REGIONAL REVIEW FINDING

ARC REVIEW CODE: R1207261

Name of Proposal: DeKalb Farmers Market
Submitting Local Government: DeKalb County

SUBJECT: **TD Review of DRI # 2273**

SHEET:
C1
DRI #2273

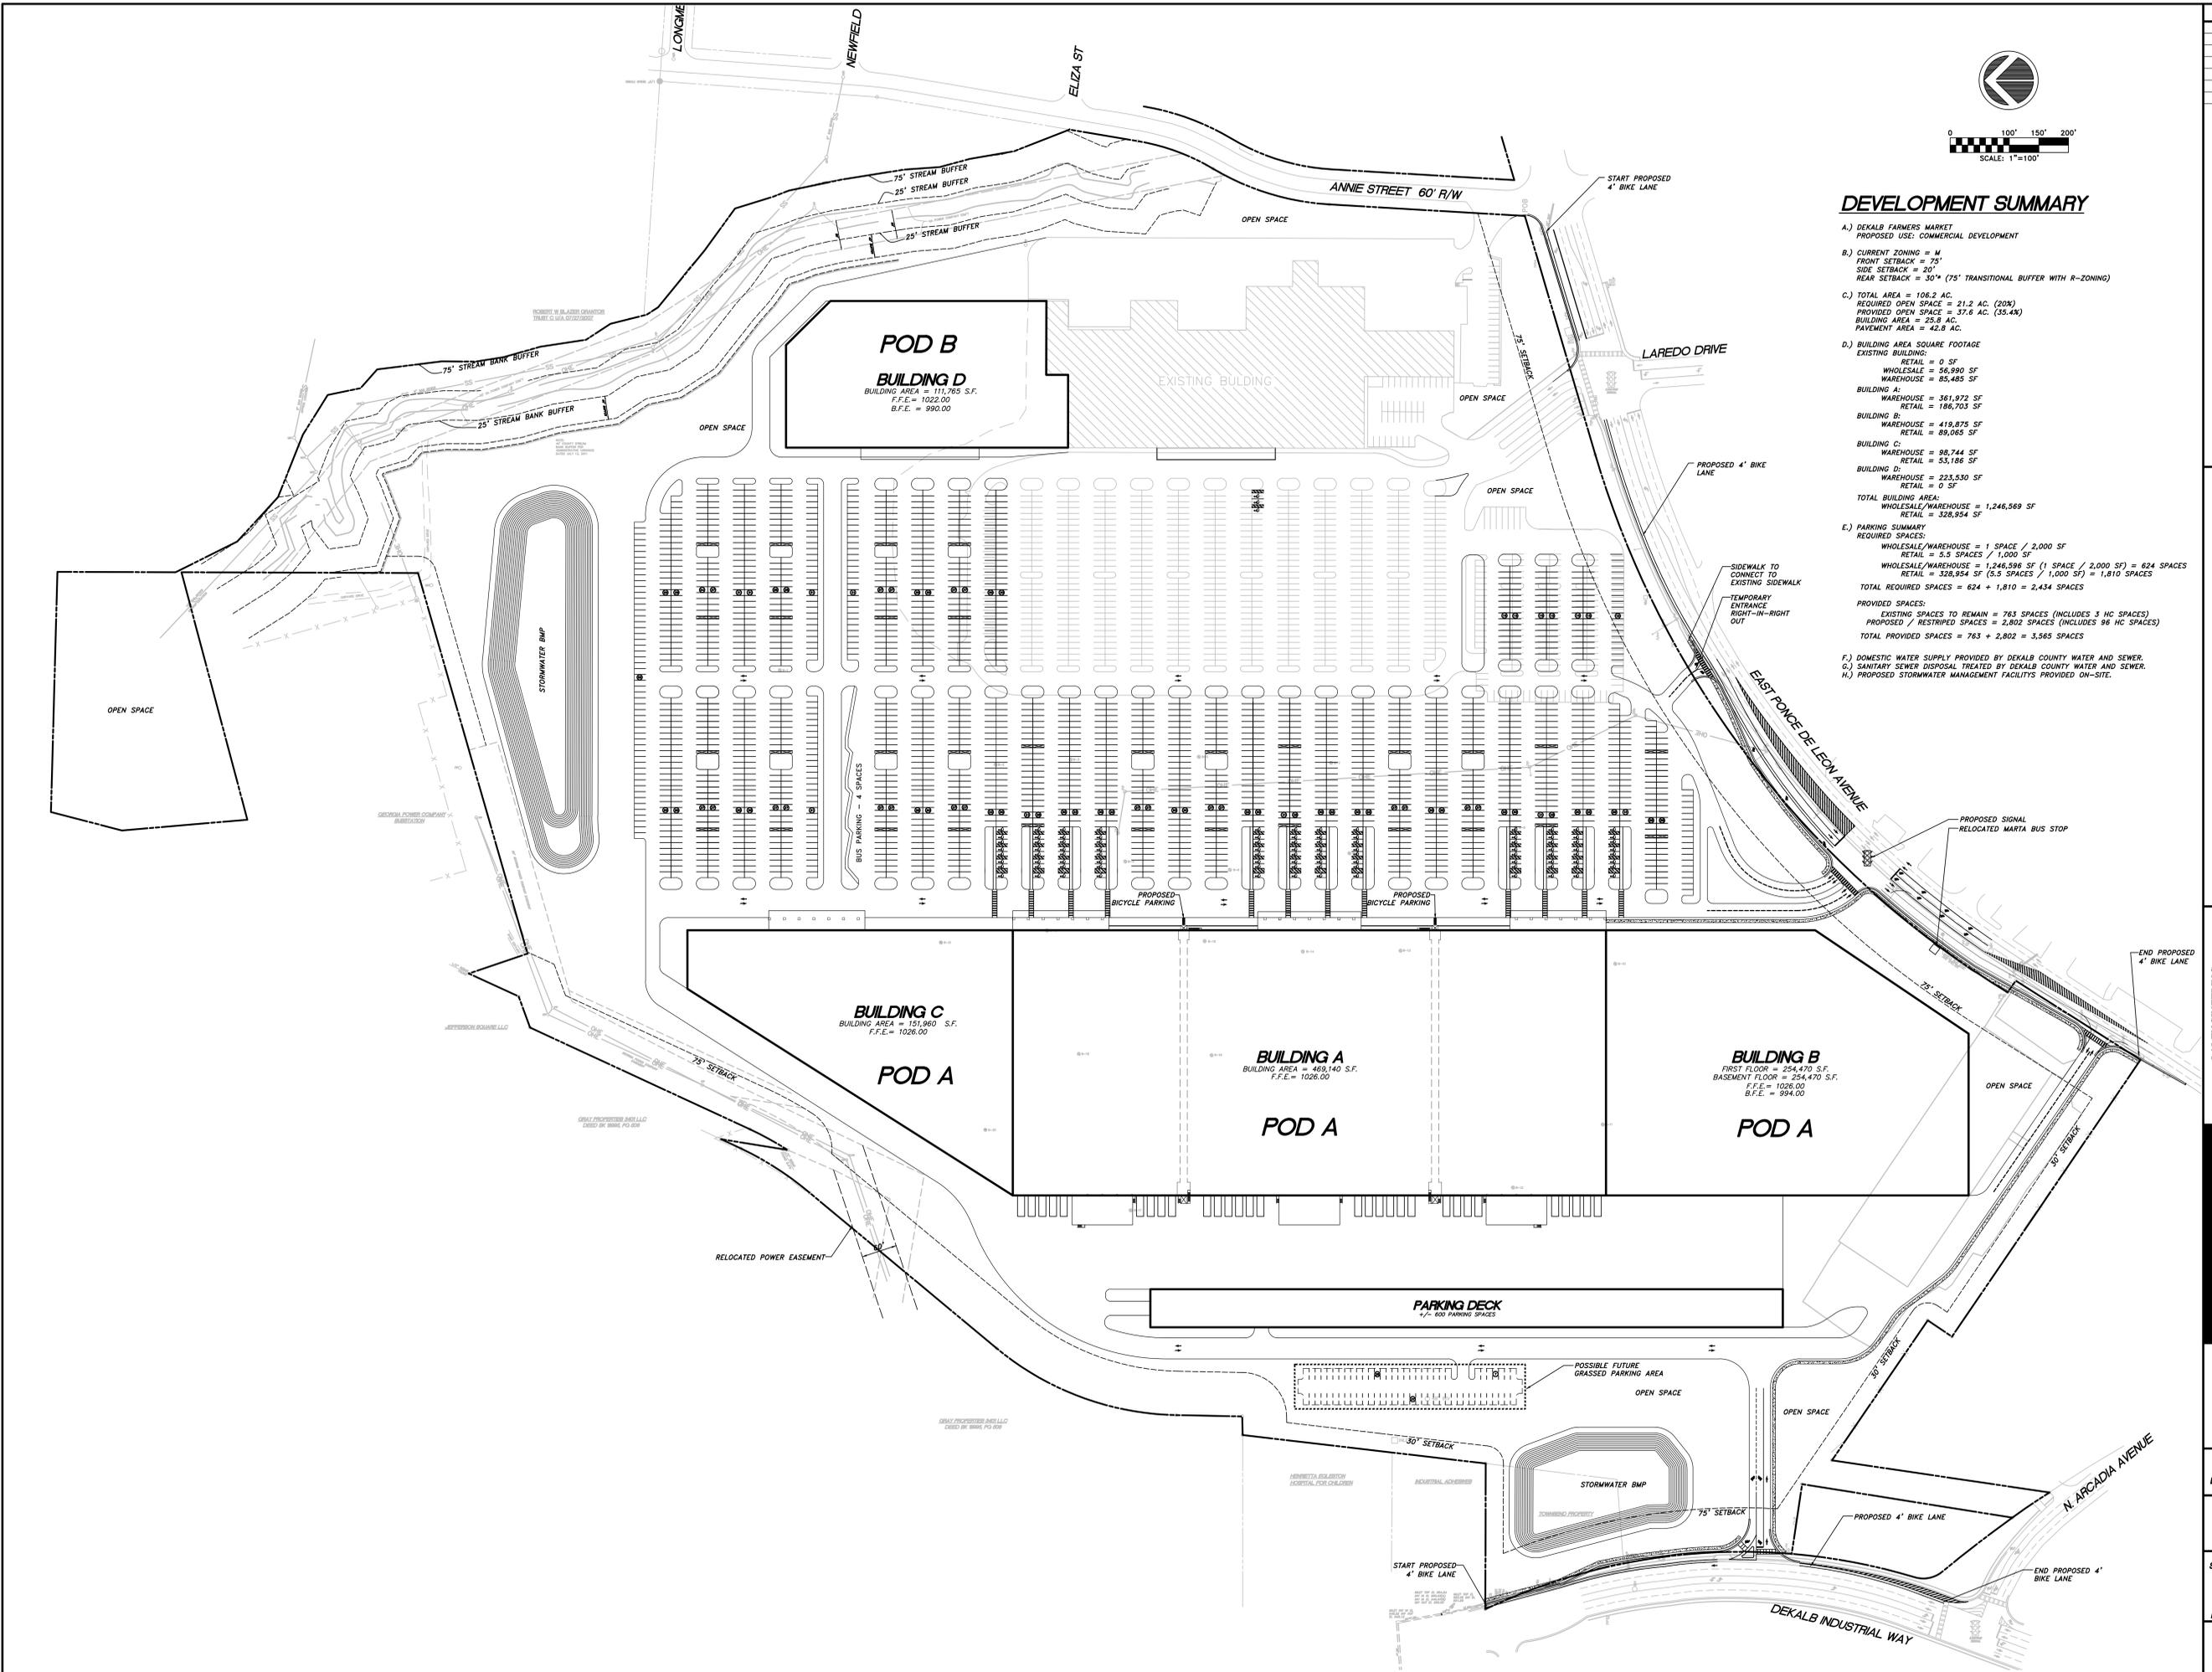
The proposed development is approximately 100 acres, with additional adjacent acreage controlled by the owner/developer. Additionally, the development is surrounded by existing industrial, residential, and commercial uses with some infill development and redevelopment occurring in and around the Cities of Decatur and Avondale Estates. The County should consider how this large in-town greenfield site could be fully utilized, given its location to other communities and MARTA rail and bus services. As proposed now, the development will have little interaction with the surrounding properties, few bicycle and pedestrian options through the site, and more parking than is required by DeKalb County zoning. This property provides a rare in-town opportunity for a large catalyst development for the surrounding area. Potential improvements to the site plan include, but are not limited to:

- Place buildings and internal driveways to produce a more urban and pedestrian friendly environment.
- Provide better bicycle and pedestrian options to the various buildings and through the site.
- Provide the ability to connect this development and its internal driveways or roads to future development on adjacent properties. This could be in the form of "stub outs" or land left vacant so as not to preclude future connections.
- Provide additional space between driveways on East Ponce de Leon Avenue.
- Use pervious materials for the parking area.
- Design storm water retention/detention areas as usable greenspace.

Does development seek shared parking arrangements that reduce overall parking needs?	<input type="checkbox"/>	<input type="checkbox"/>	<input checked="" type="checkbox"/>			
Does development use landscaped tree islands and medians to break up large expanses of paved parking?	<input type="checkbox"/>	<input type="checkbox"/>	<input checked="" type="checkbox"/>			
Is the development's parking located where it does not visually dominate the development from the street?	<input type="checkbox"/>	<input checked="" type="checkbox"/>	<input type="checkbox"/>	0	PARKING IS LOCATED IN THE CENTER OF THE DEVELOPMENT	SHIFT BUILDINGS, INTERNAL DRIVES AND PARKING TO BREAK UP AND SCREEN THE PARKING FROM VIEW
Does the parking design allow for easy and safe pedestrian access to buildings?	<input type="checkbox"/>	<input checked="" type="checkbox"/>	<input type="checkbox"/>	0	NO PEDESTRIAN ACCESS IS INDICATED ON THE SITE PLAN
